DOCKETED						
Docket Number:	20-AAER-02					
Project Title:	Air Filters					
TN #:	248146					
Document Title:	Jeff Miller, PE comments to docket 20-AAER-02 regarding 3rd 15-day language (TN247899) for proposed air filter label regulations					
Description:	N/A					
Filer:	System					
Organization:	Jeff R Miller, PE					
Submitter Role:	mitter Role: Public					
Submission Date:	12/18/2022 7:06:39 PM					
Docketed Date:	12/19/2022

Jeff Miller, PE comments to docket 20-AAER-02 regarding 3rd 15-day language (TN247899) for proposed air filter label regulations

Figure 2. Table Z copied from the 15-day language from the 2015 air filter label rulemaking.

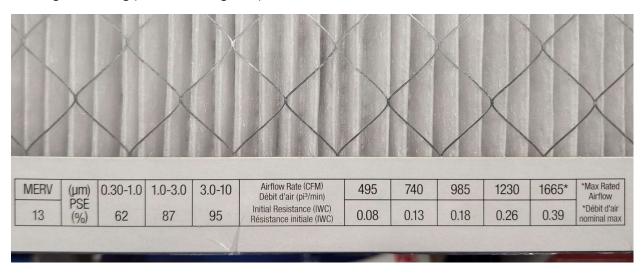
An example of the improvements to the appearance of the layout and formatting I recommend is shown in Figure 2 below. The graphic in Figure 2 displays a copy of the air filter label marking layout and formatting that was posted in the 15-day language adopted by the 2015 air filter label rulemaking (although the asterisk that should be placed next to "val 5" was erroneously missing from that posting). The same layout and formatting is published in the Appliance Efficiency regulations available at the following URL:
